34th Street Pump Station Improvements Project
SAWS Job No. 13-6004
Solicitation No. CO-00072-RA

ADDENDUM No. 7

October 21, 2016

I-004

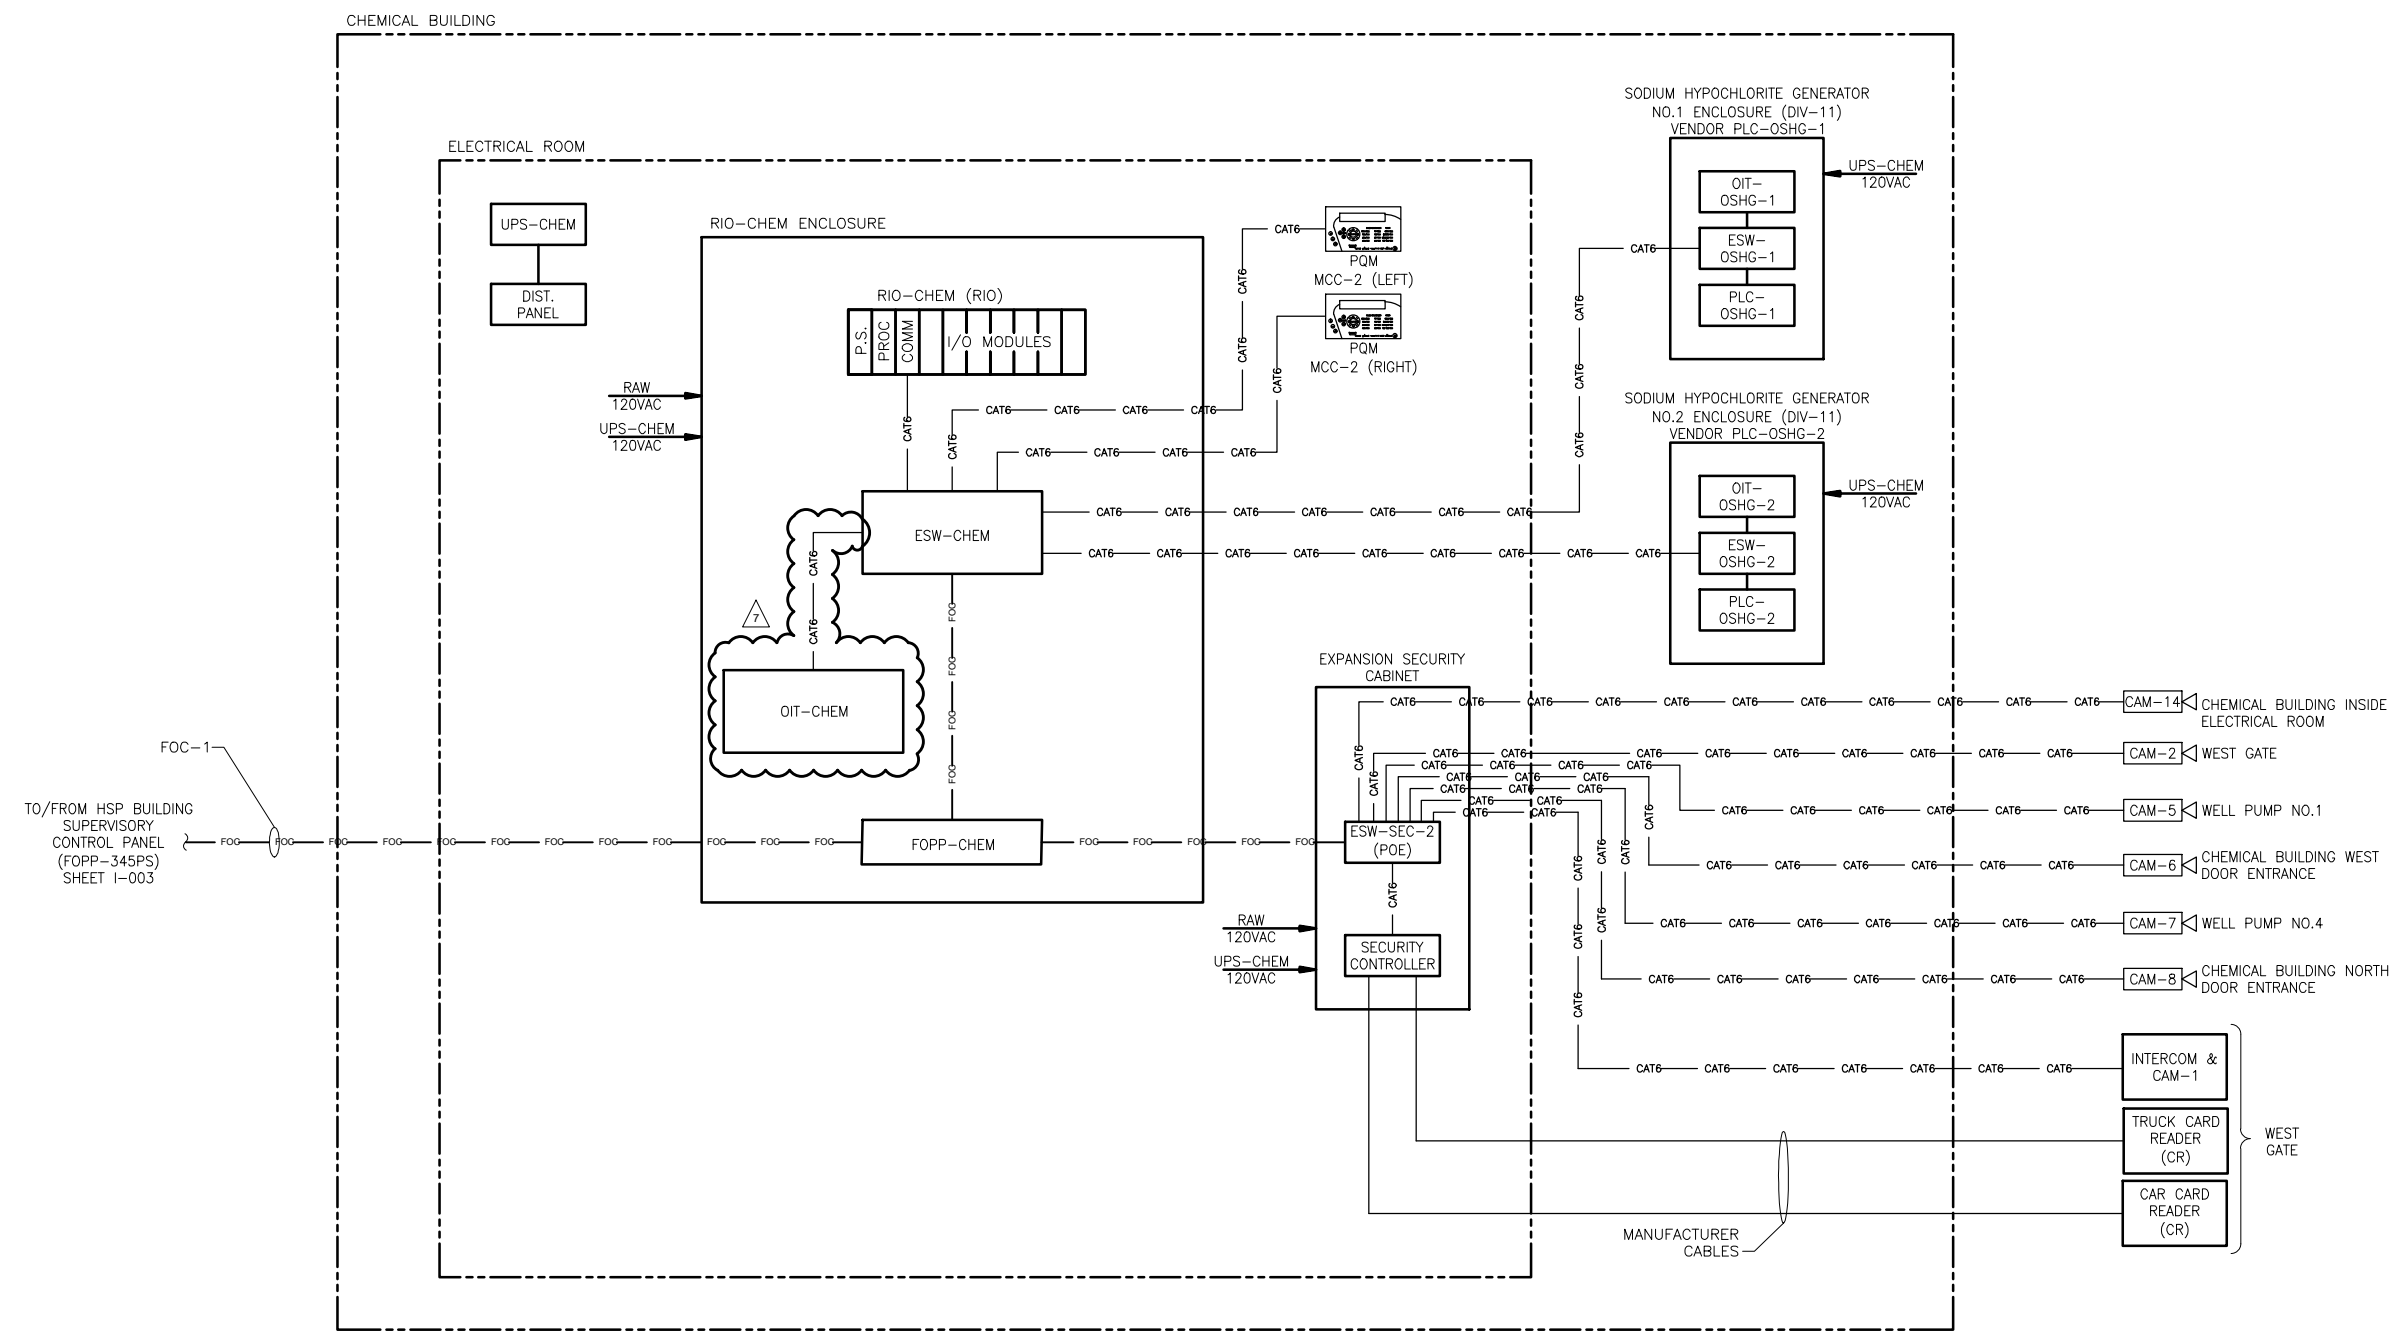
Modify Drawing to include a new OIT-CHEM that will be mounted on the RIO-CHEM Enclosure door. OIT-CHEM will be connected to ESW-CHEM via CAT6 Ethernet cable.

I-401

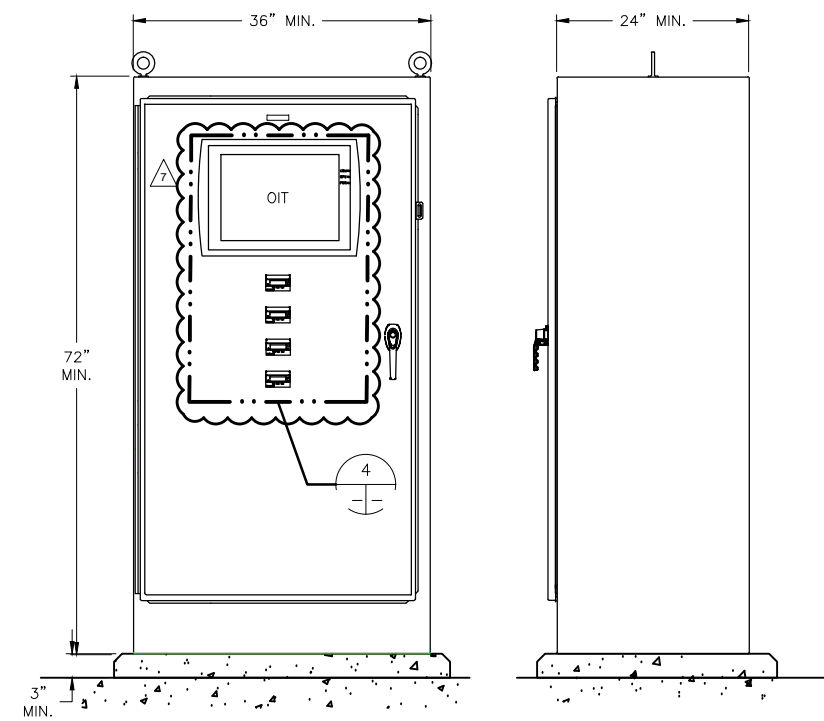
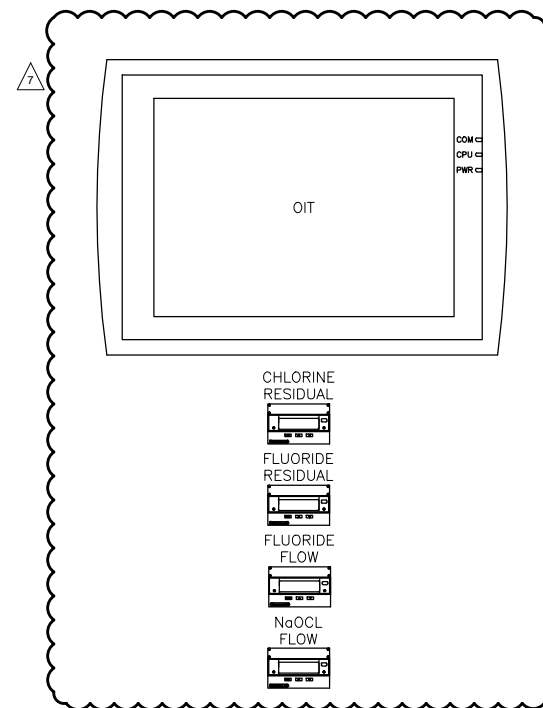
Modify Detail 3 and Detail 4 to include a new OIT-CHEM that will be mounted on the RIO-CHEM Enclosure door just above the Chlorine Residual Indicator.
